Subject: FW: Planning application 31 Ferncroft avenue, London NW3 7PG

Further to our conversation yesterday, I would like to object to the proposed planning application number 2017/1953/P.

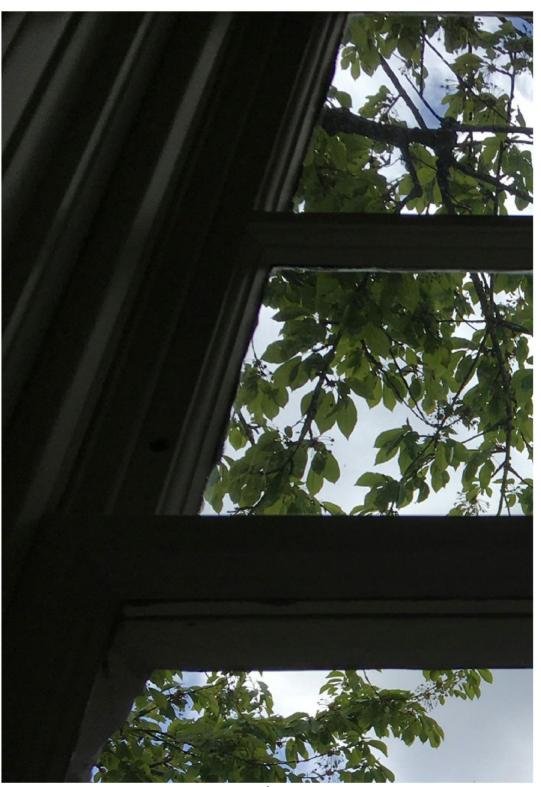
Ground floor room on west side

Same room as aboven.g - from this photo you can see that the existing extension is already obstructing our window

Same room as above will be significant.	from a different angle of - if the terrace was going to be removed at 31 Ferncroft, the reduction of daylight

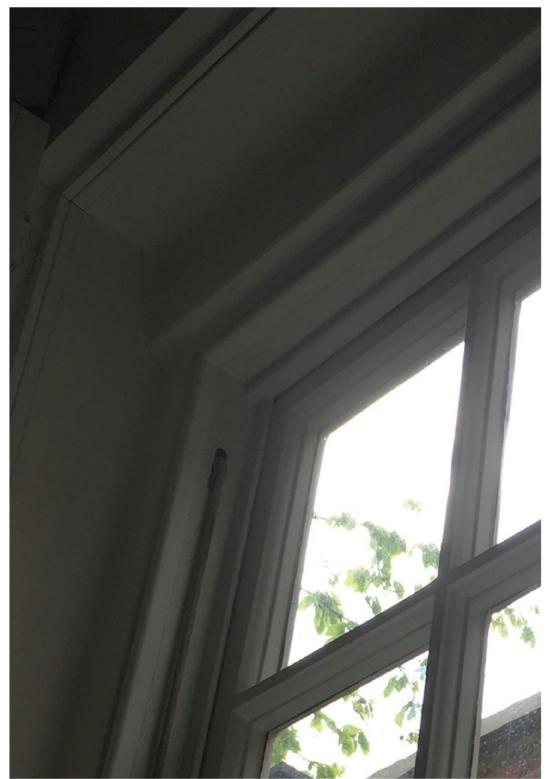
Another room on the ground floor - west side - facing a window at 31 Ferncroft that is to be removed in the proposal.

Same room as above from another angle showing that the daylight comes from above the terrace at 31 Ferncroft.

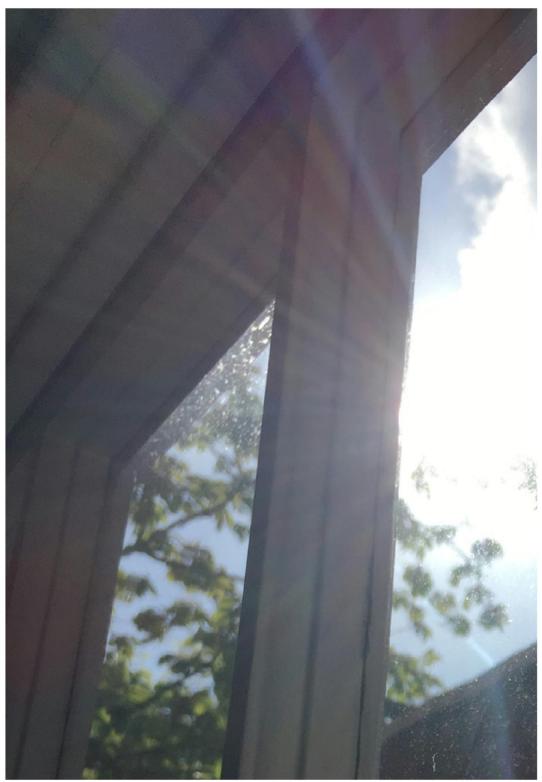
Same room as above - benefiting from sunshine

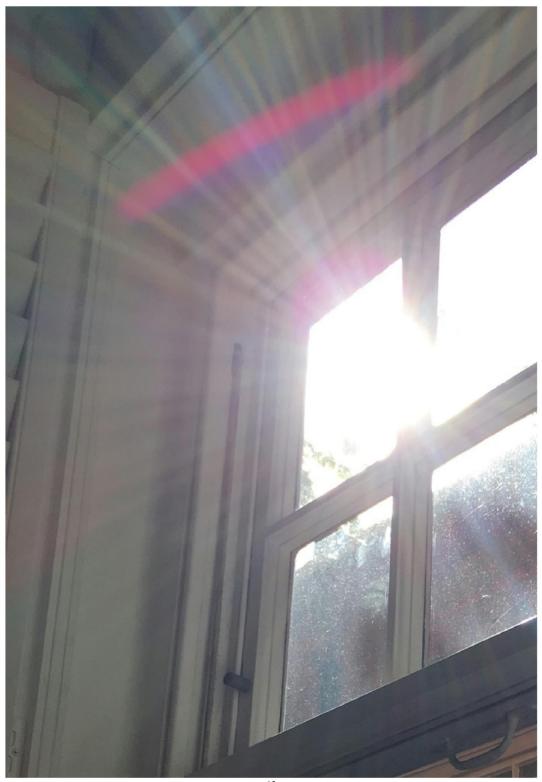
Same room as above - with the proposed extension we will not get the sunlight.

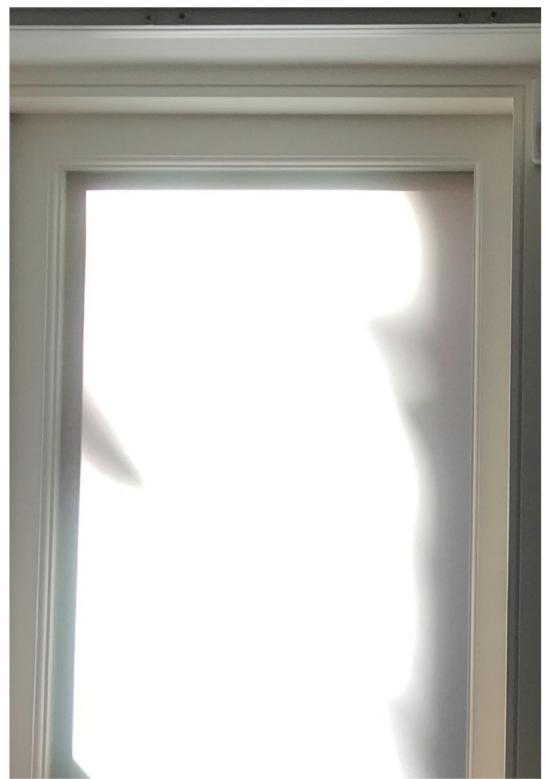
Same room as above - the sunlight makes a huge difference

Room at lower ground floor - west side - showing the contrast of darkness and brightness due to sunlight.
